## **LIPSCOMB-JACKSON SUBDIVISION**

APPLICATION NUMBER 9 DATE August 8, 2013  
APPLICANT Lipscomb - Jackson Subdivision  
REQUEST Subdivision

# DETAIL SITE PLAN

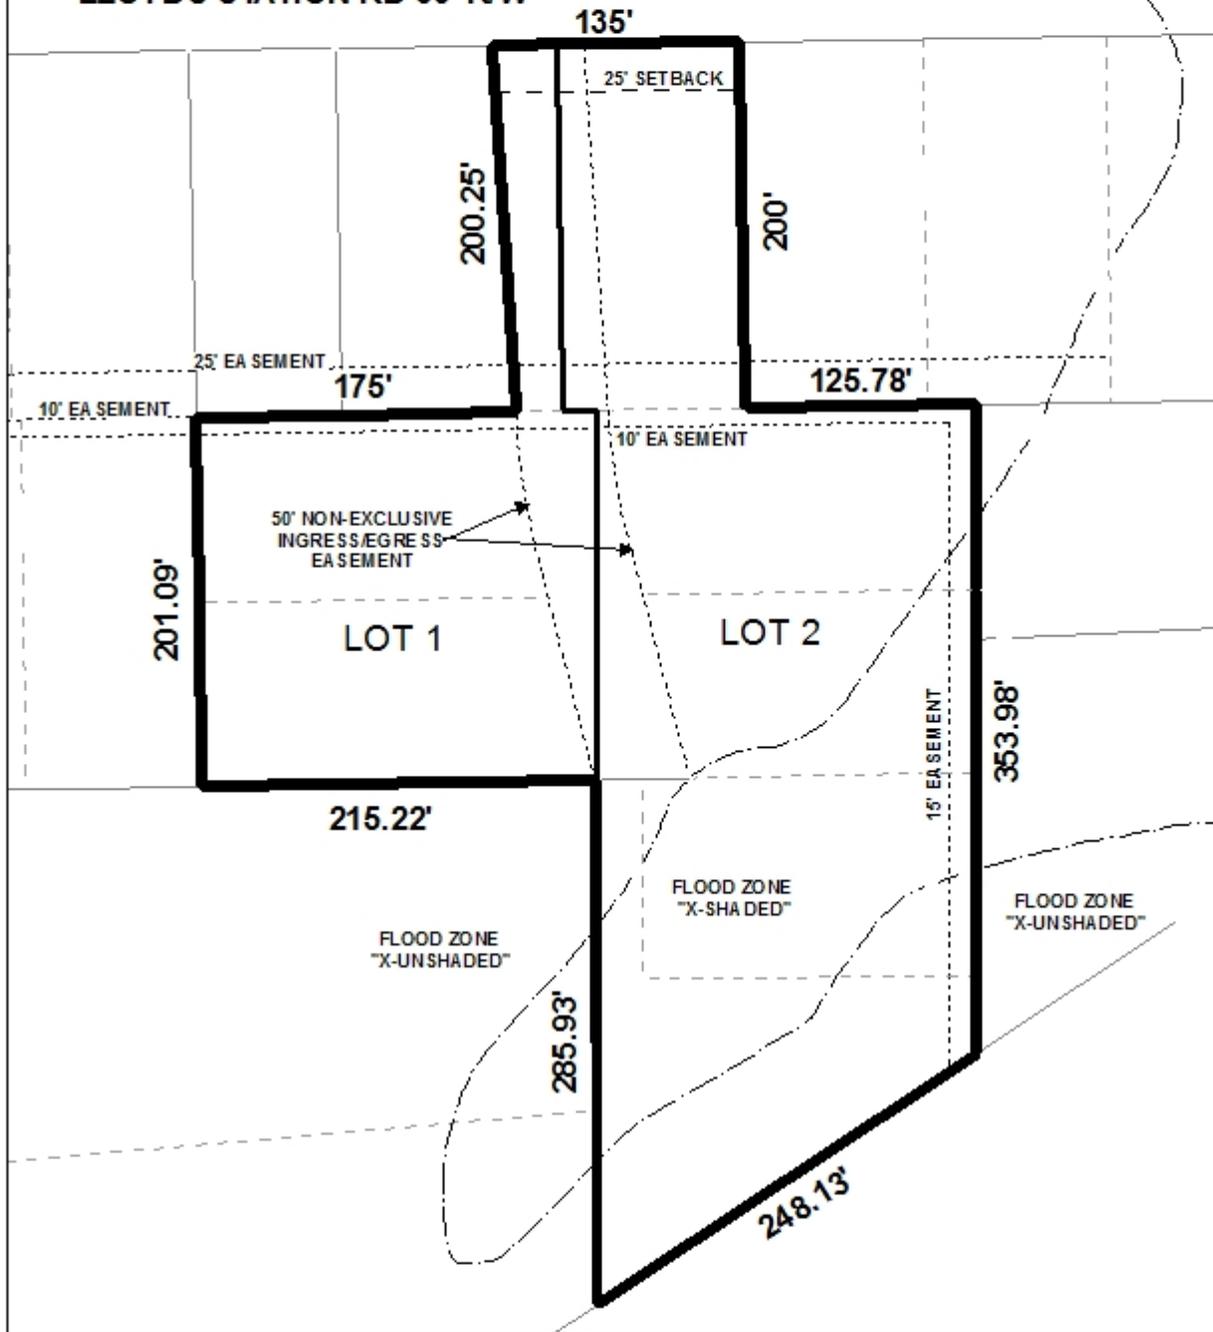
There seems to be several discrepancies with the preliminary plat. The lot size information is not depicted for either lot and the 25-foot minimum setback line for Lot 1 should be revised and depicted as a box where the "Flag" meets the "Pole" of the lot if approved. Also, the Point of Beginning location should be revised as well, as they appear to contain errors.
